2017 Annual Dam and Dike Inspection Report

Primary Ash Dam

**Flint Creek Plant
Southwestern Electric Power Company
Gentry, Arkansas**

Document ID: GERS-17-056

PROJECT			
AMERICAN ELECTRIC POWER LITTLE FLINT CREEK GENERATING STATION			
TITLE			
LOCATION OF PIEZOMETERS			
PROJECT No.	09390068.11	FILE No.	LFC-FIG
DESIGN	XXX XXX	SCALE:	1:2,400 REV. 0
GIS	MTC 11/03/2011	1	
CHECK	RIO 12/05/2011		
REVIEW	RIO 12/05/2011

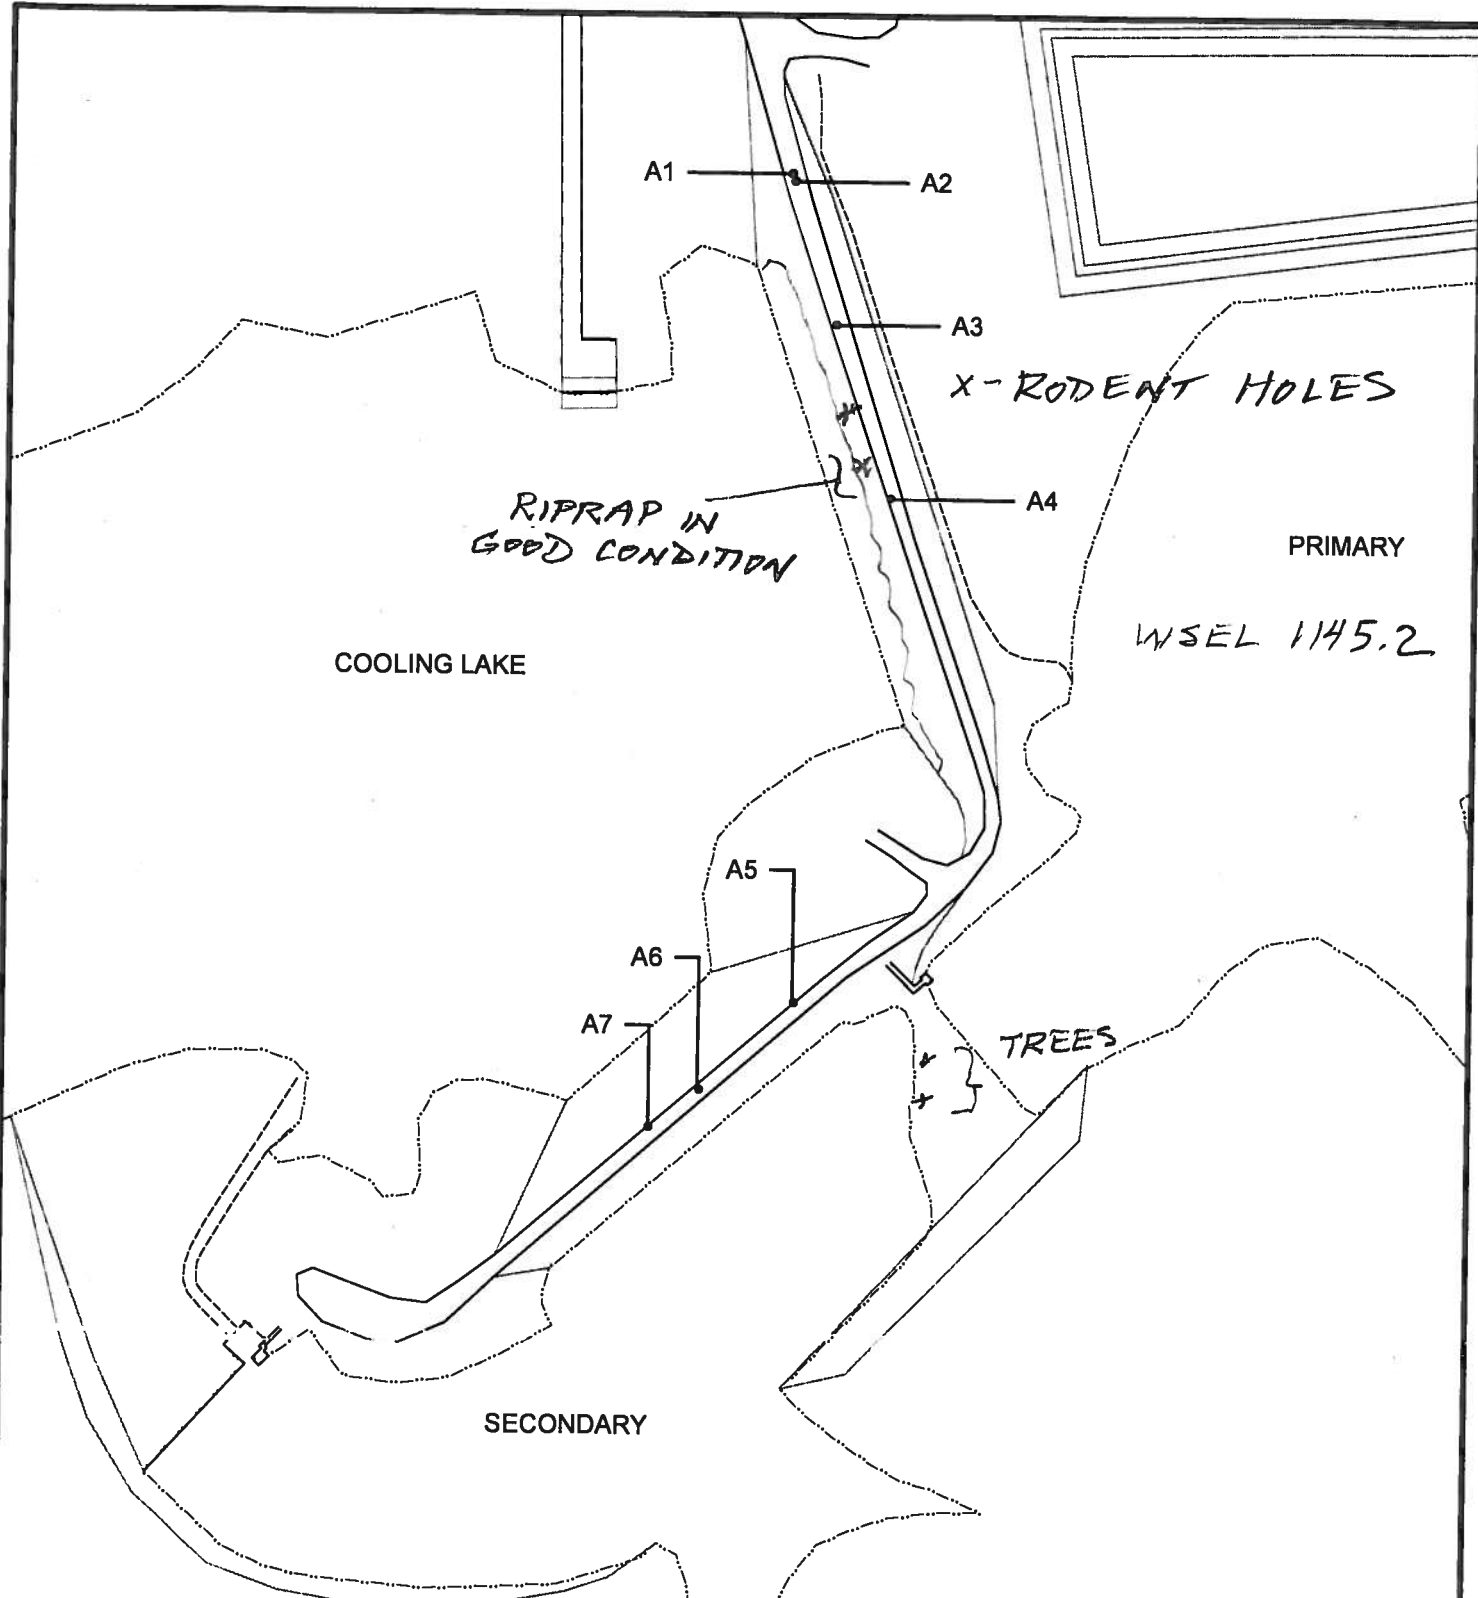
The following maintenance items were identified during the visual inspection, see inspection map for locations. Contact GES for specific recommendations regarding repairs:

- Repair rodent holes flagged during the inspection and others as discovered during the 7-day inspections.
- Continue the vegetation control plan of mowing and spraying.
- Remove woody vegetation in the natural ground below the emergency spillway from the Primary Bottom Ash Pond.

4

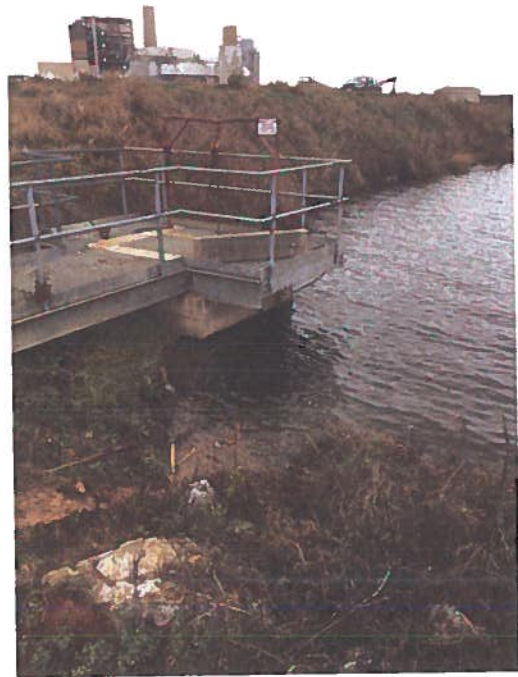
The principal spillway at the primary impoundment is a concrete drop-inlet structure with stop logs used to control the pool elevation. The spillway was in generally fair condition (photo 2). Flow through the principal spillway was unobstructed.

The emergency spillway at the primary impoundment is an incised channel in natural ground with a concrete weir control section, 1 ft. in height, across the channel width. The spillway was in generally fair condition at the time of inspection (photo 1). The spillway appeared to be generally stable.

Spillways

#1 - concrete sill in emergency spillway

#2 - principal spillway structure
